## TECHNICAL SERVICE BULLETIN

### TB08-102 R-M

**TO: NORDYNE DISTRIBUTORS  
NORDYNE DEALERS**  
**FROM: TECHNICAL SERVICE DEPARTMENT**  
**DATE: February 11, 2008**  
**RE: Chattering Check Valve on the GB5BW Air Handlers**

## 632392R - Magnet Kit GB5BW

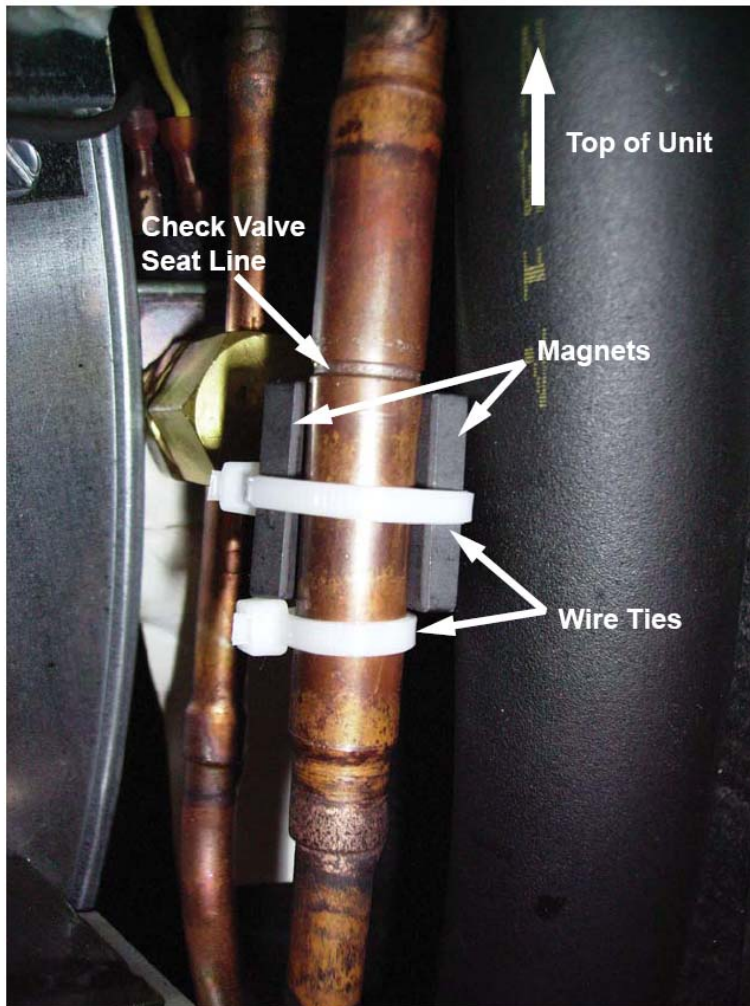
Nordyne has received reports of **GB5BW** air handlers that have a chattering or rattling noise in the coil. The noise is caused by a missing spring in the check valve assembly.

Locate the magnets as shown with the top of each magnet at or slightly below the check valve seat mark on the check valve body.

The top wire tie serves to hold the magnets against the check valve body.

The bottom wire tie can be replaced by tar tape or any other means of preventing the magnets from slipping down the in the check valve.

In the interim Nordyne recommends that a magnet kit (632392R) should be use to correct the noise issue. Attached are the Installation Instructions for the magnet kit.
